Work Order ID 126369

Item ID: D2965-3

Item Name: Cap

DESIGN	814	DRAWN BY	814	DART AEROSPACE USA, INC.	
				PORT HADLOCK, WA	
CHECKED	<i>[Signature]</i>	APPROVED	<i>[Signature]</i>	DRAWING NO.	D2965
DATE	06.11.01	TITLE	CAP	REV. B	
				SHEET 1 OF 2	
				SCALE	1:2
A	00.02.24	NEW ISSUE			
B	06.11.01	ADD -3 CAP

D2965-3 CAP MACHINING DETAIL
(MAKE FROM D2965 CAP)

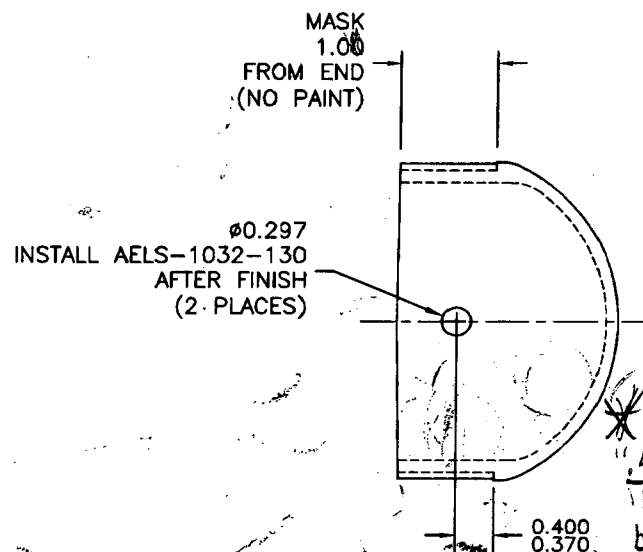
* Dimensions
"400-370"
Needs to
be changed
to "460-430"
for proper
Fit.
